PRODUCT CHANGE NOTICE

SUBJECT: Embossed Tape and Reel
Product: Electric Double Layer Capacitor(Gold Capacitor)
Series: EM-/EN-/EP-/ER-Series
P/Ns:
 EECEMxxxxxx
 EECExxxxxx
 EECEPxxxxxx
 EECERxxxxxx

EFFECTIVE DATE: Jan. 1, 2011 (Running Change)

(1) Reel

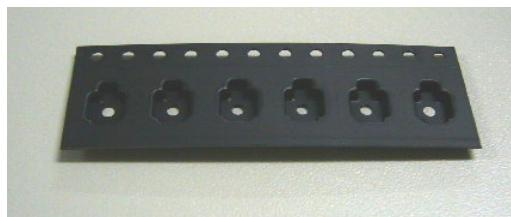
Material of the reel

Current
PS(Recycled) Color: Black or White

New
PS(New) Color: White

(2) Embossed tape

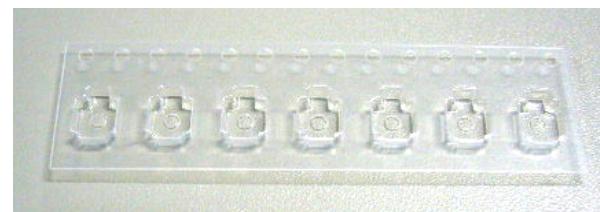
Material of the tape

Current
PS(Carbon contained) Color: Black

New
PS Color: Clear
